GS# 210-068 NEW ADMINISTRATION BUILDING PHASE II

Mississippi Delta Community College

Addendum No. 2

SHEET
E100
SZZARCH# 1956
DRAWN BY: Author
CHECKED BY: Checker
DATE: 02.17.2020

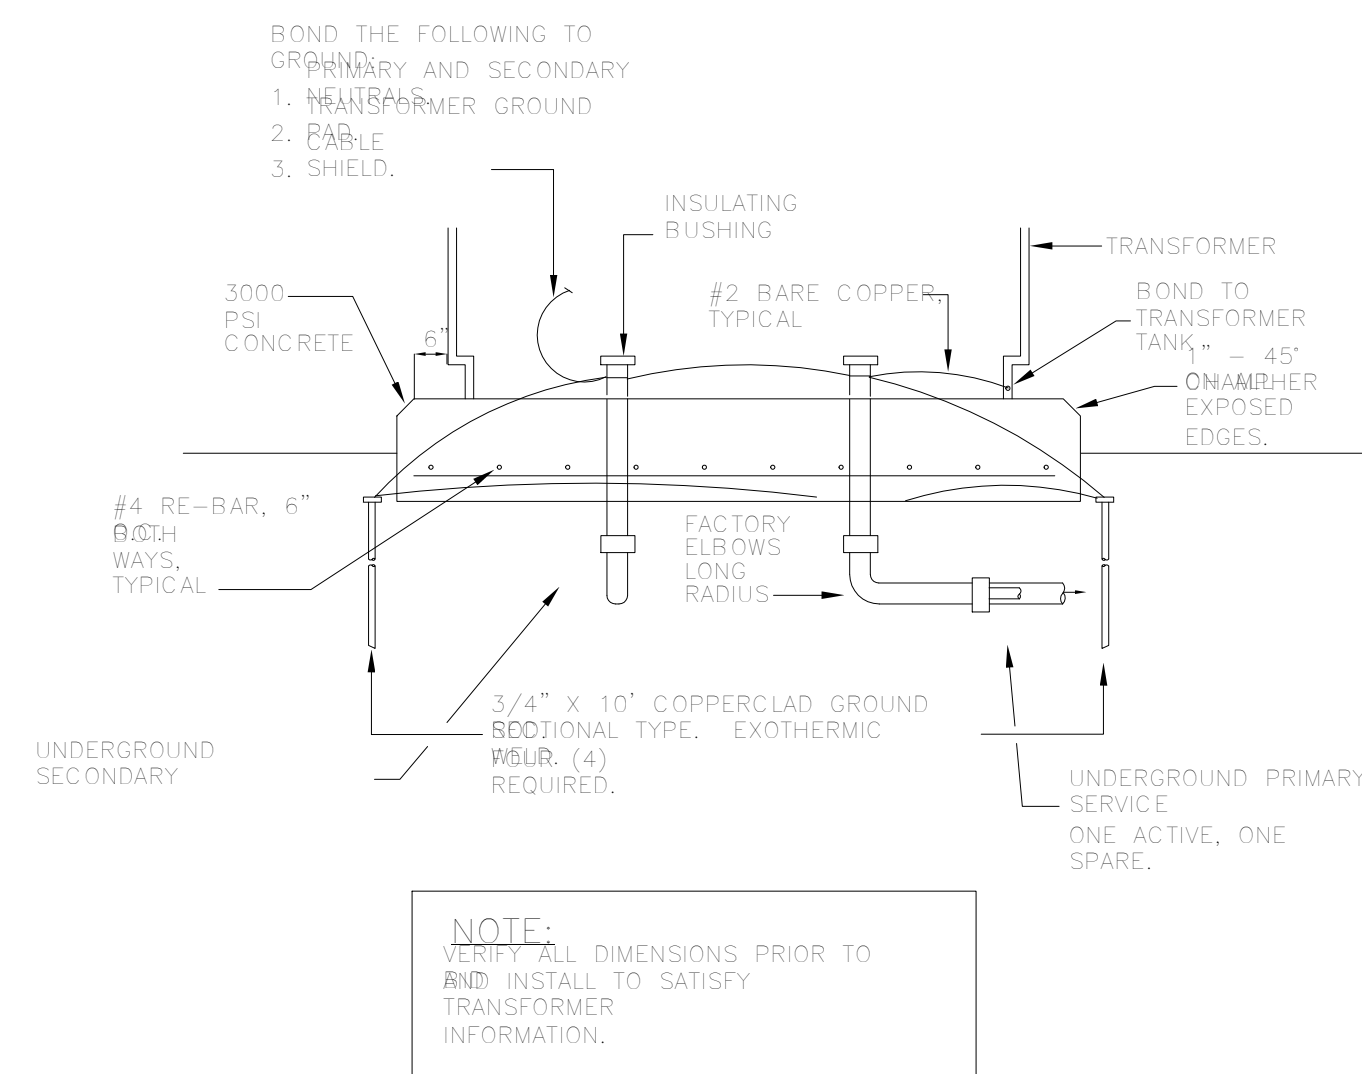
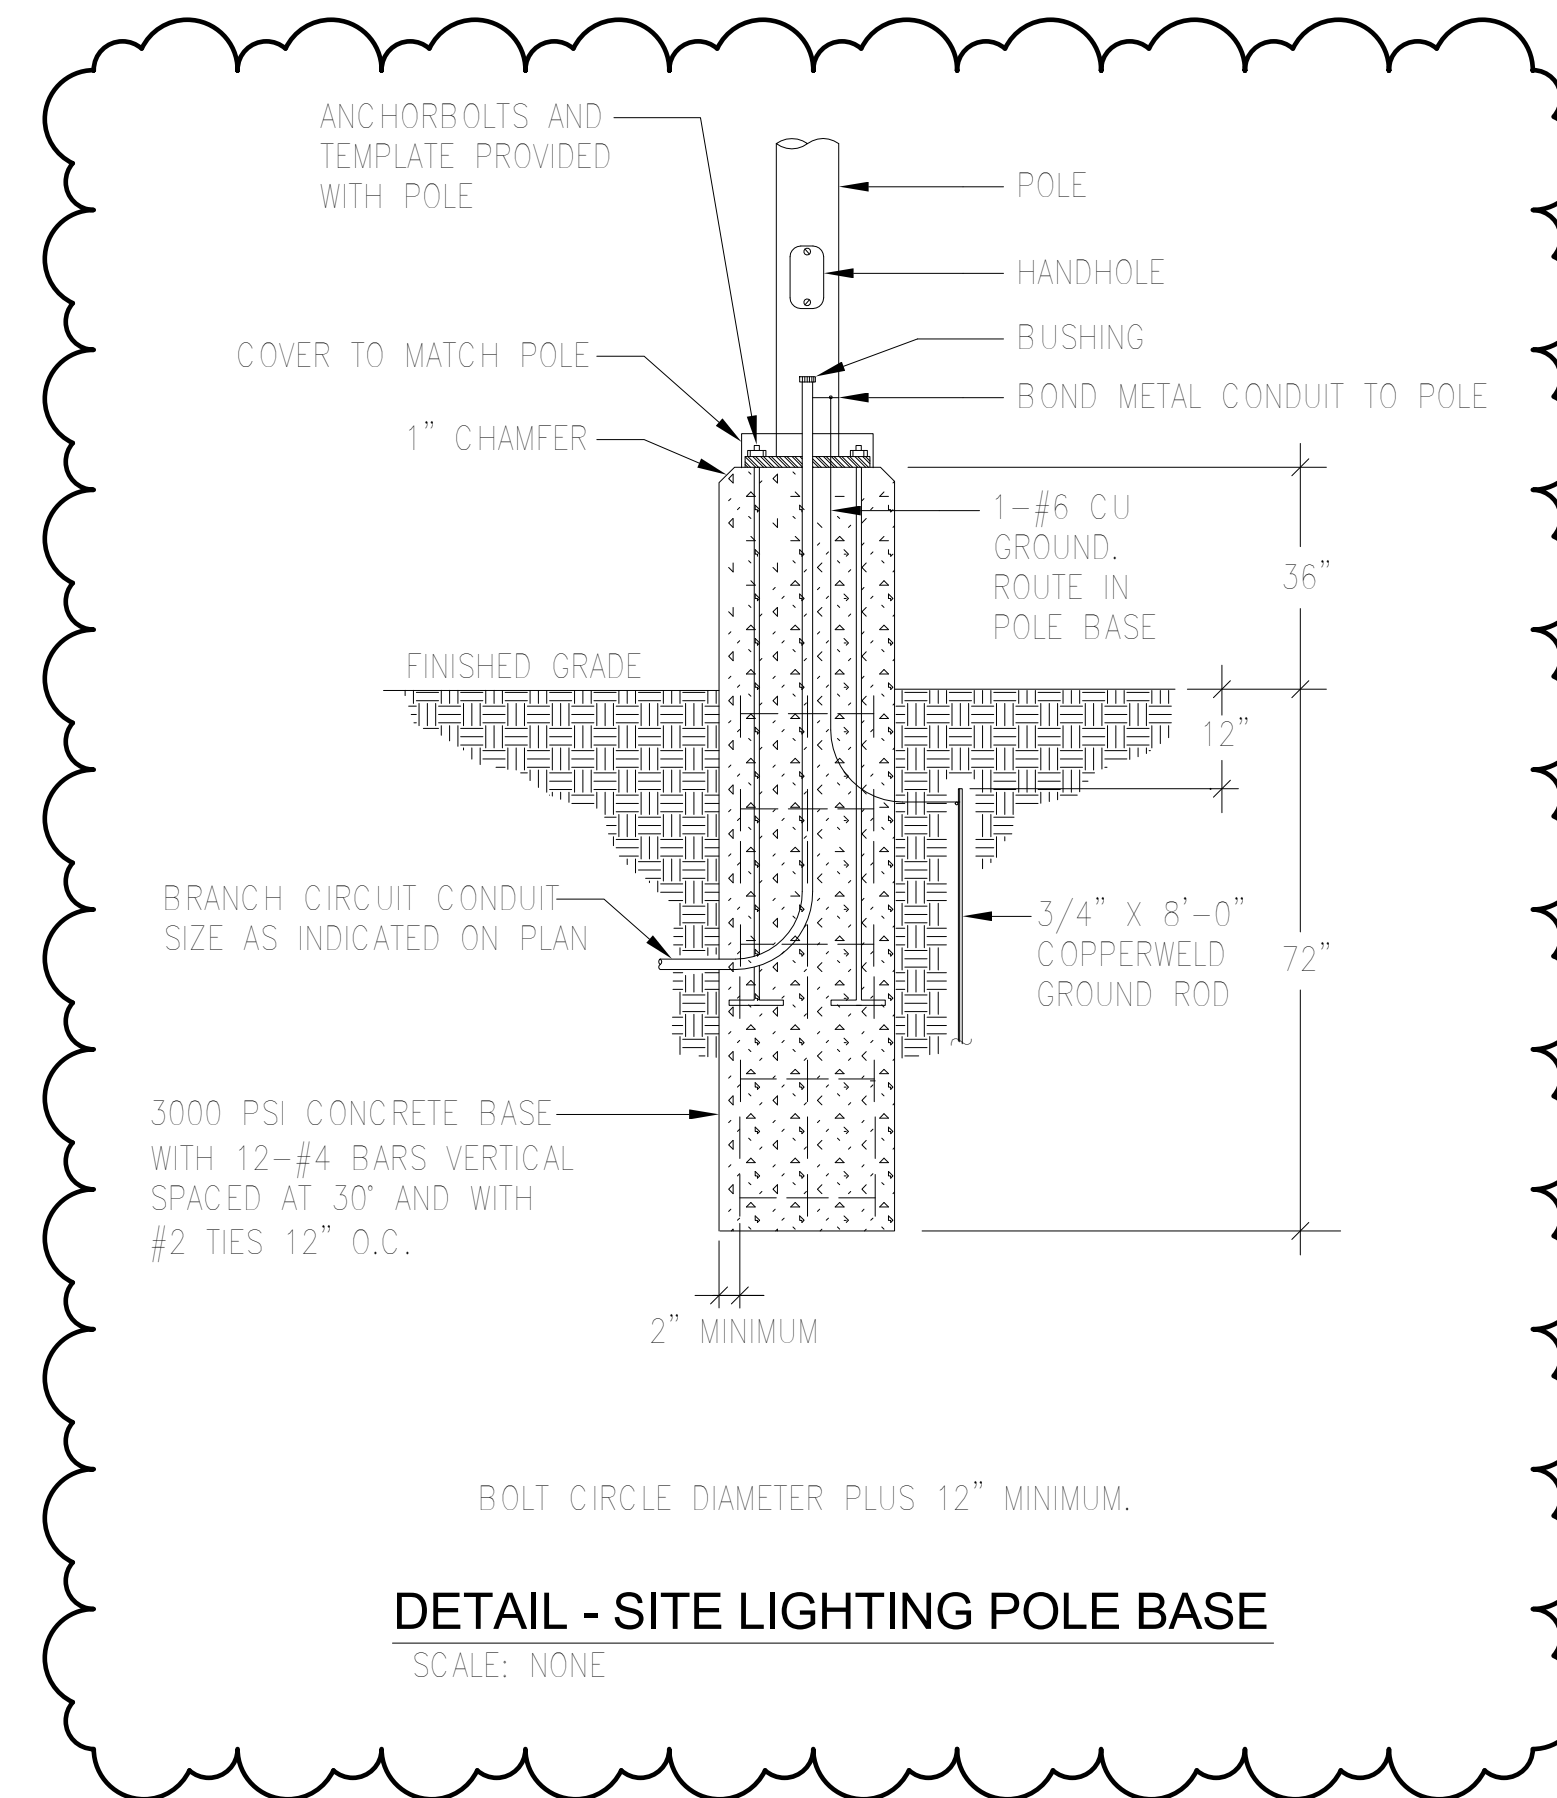
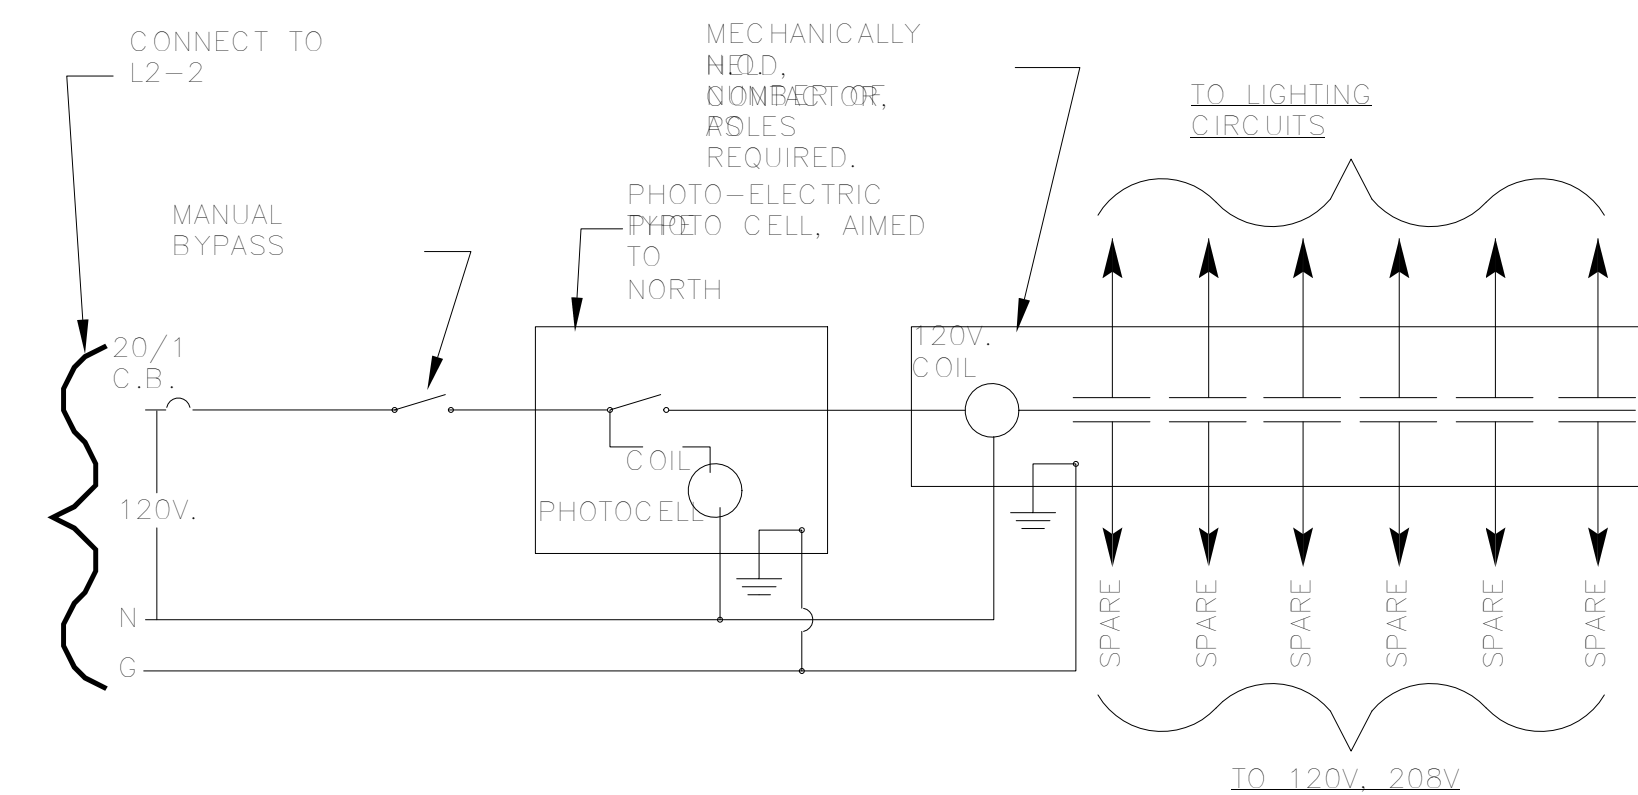
- a. Sheet A223
 - i. 7/A223 – REVISE 'FIN WD CABINETS W/ ADJUSTABLE SHELF' TO 'PLAM CABINETS W/ ADJUSTABLE SHELF'.
- b. Sheet A610 Finish Schedule – where discrepancies exist between Finish Schedule and Floor Finish Plan for flooring types, the Floor Finish Plan shall govern. See A140 Finish Floor Plan.
- c. Sheet E001: Revised minimum conduit size to ½"
- d. Sheet E002: Added pole base detail.
- e. Sheet E100: Added Mezzanine plan and revised switching in mechanical access to manual from occupancy sensor.
- f. Sheet E300: Added duct smoke detectors for IHP-2-1. Clarified via note requirements for voice alarm, testing, and CCTV/Access Control scope.
- g. Sheet ES100: Added sign lighting across the street, a sign lighting specification, and altered incoming utility route to include pad mounted transformer. Clarified conduit entrance for communications.

1 Lighting Plan
1/8" = 1'-0"

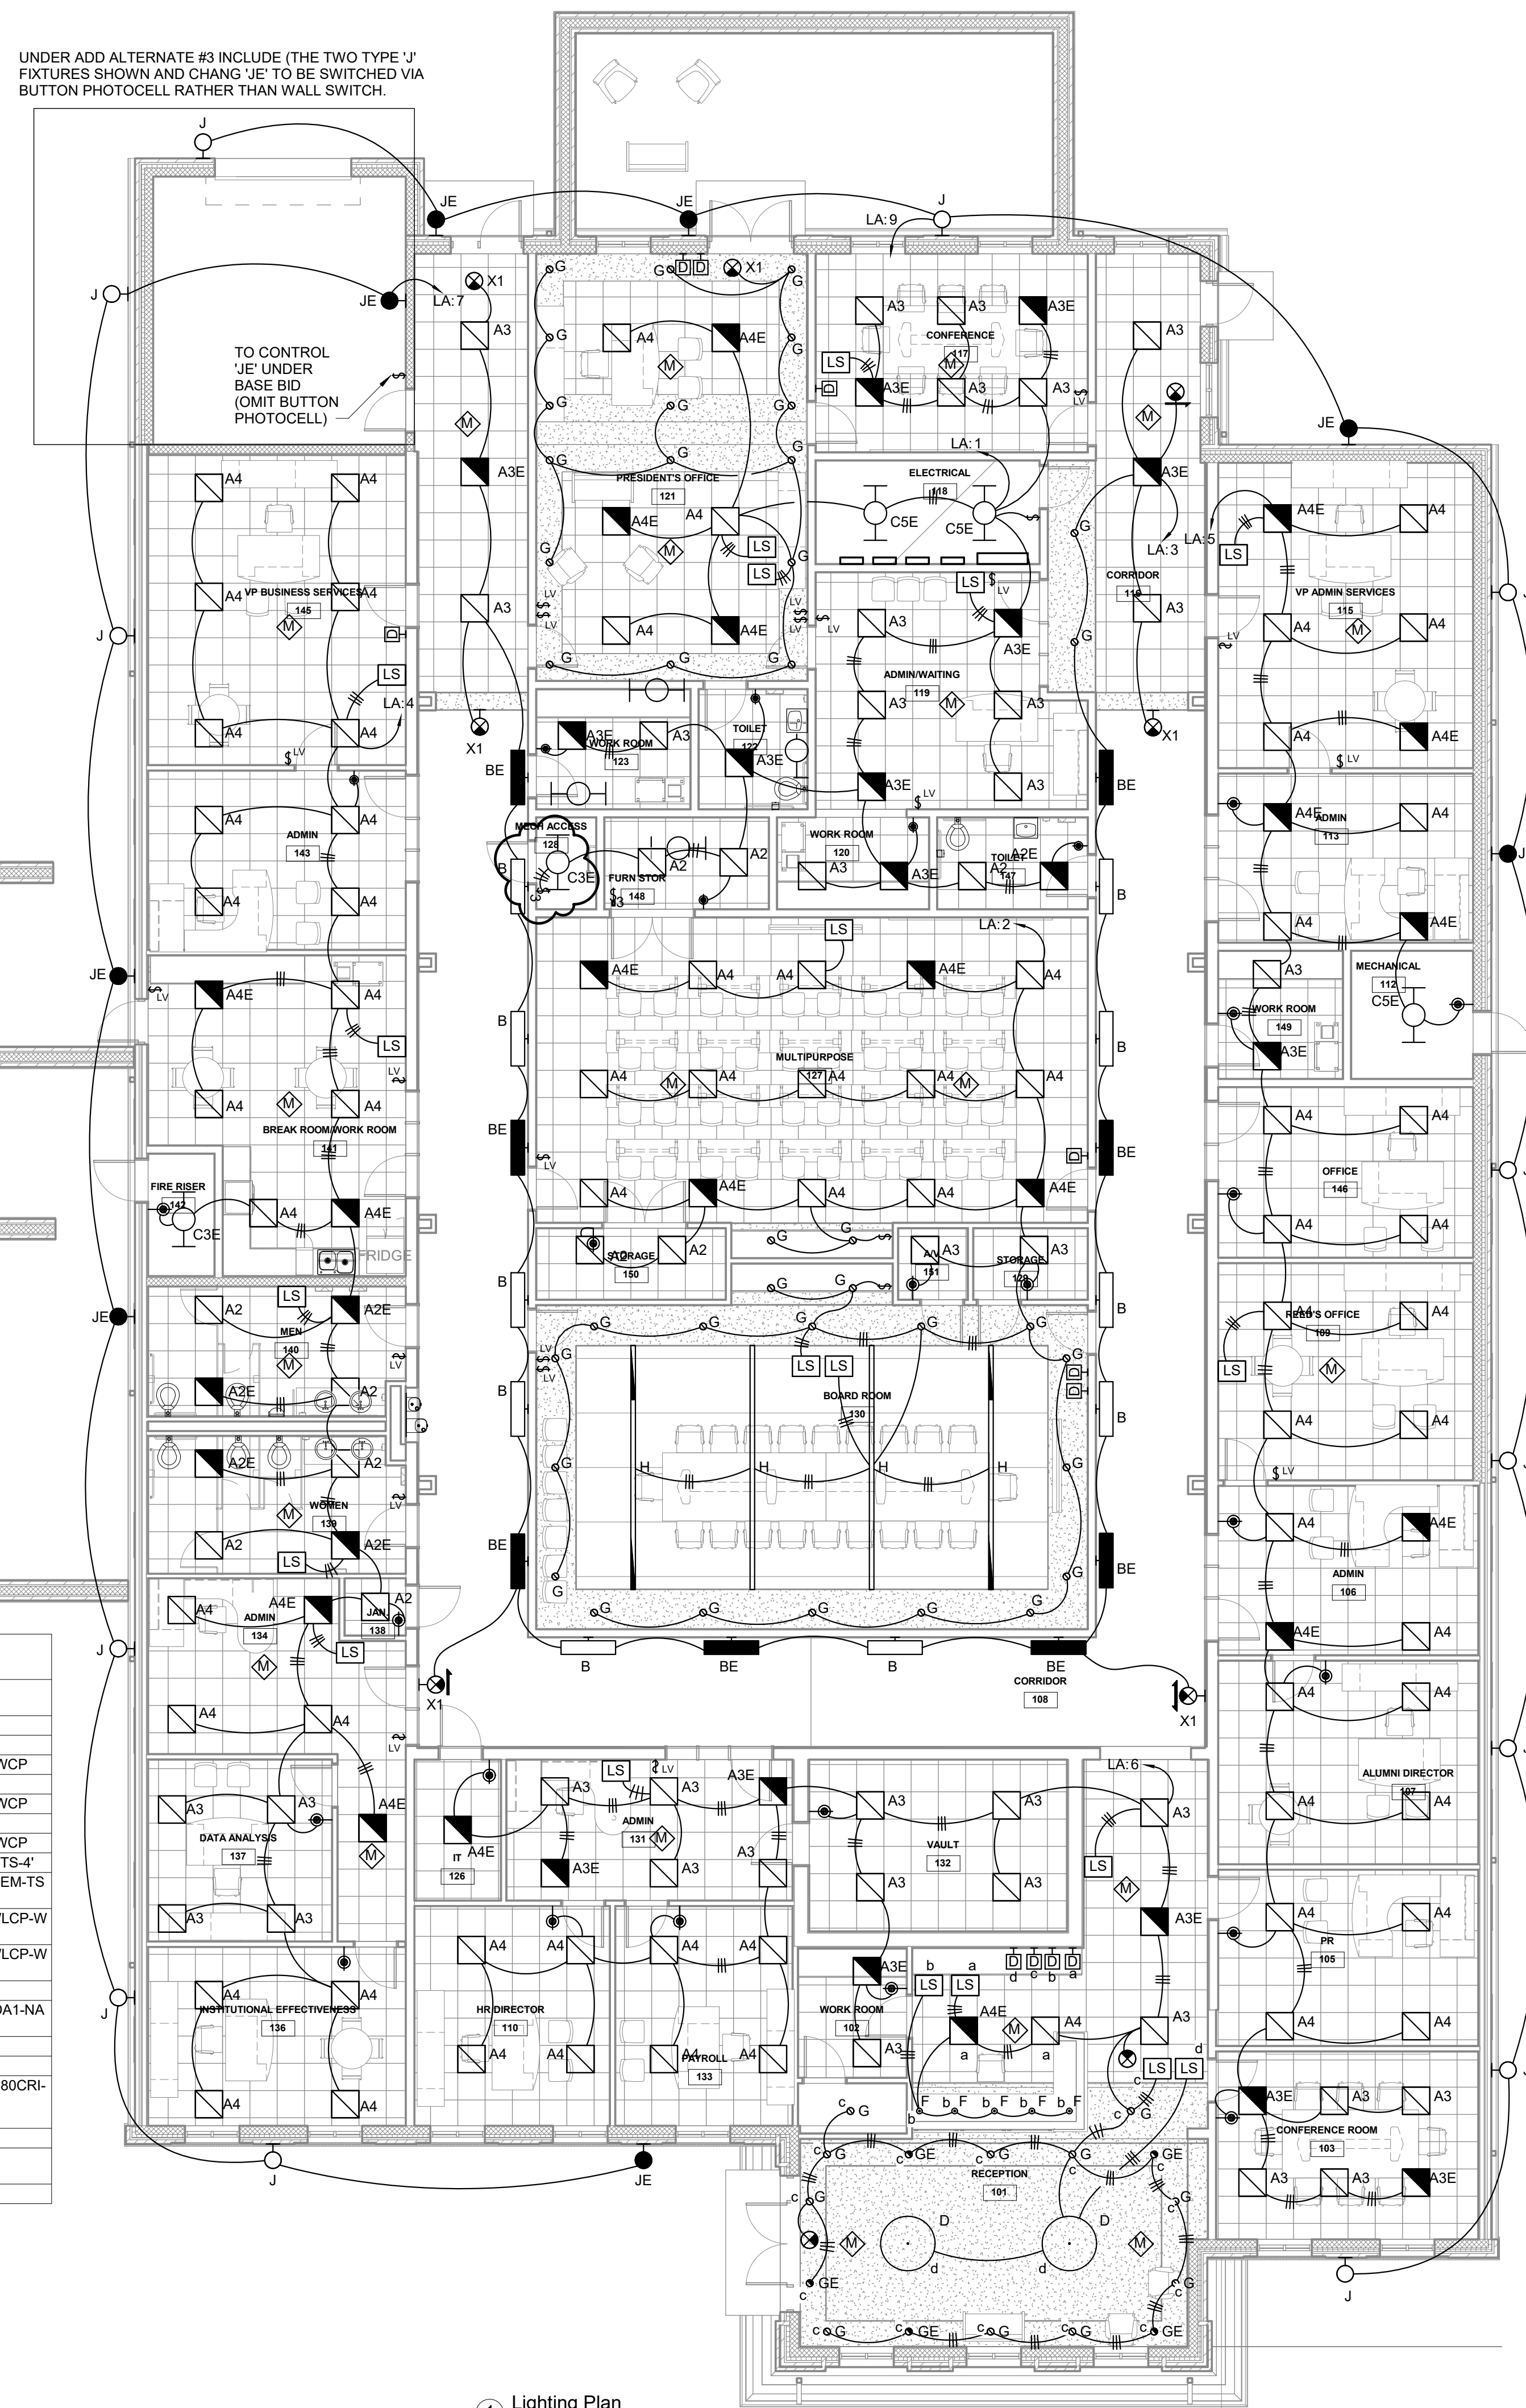
UNDER ADD ALTERNATE #3 INCLUDE (THE TWO TYPE 'J' FIXTURES SHOWN AND CHANG 'JE' TO BE SWITCHED VIA BUTTON PHOTOCELL RATHER THAN WALL SWITCH.
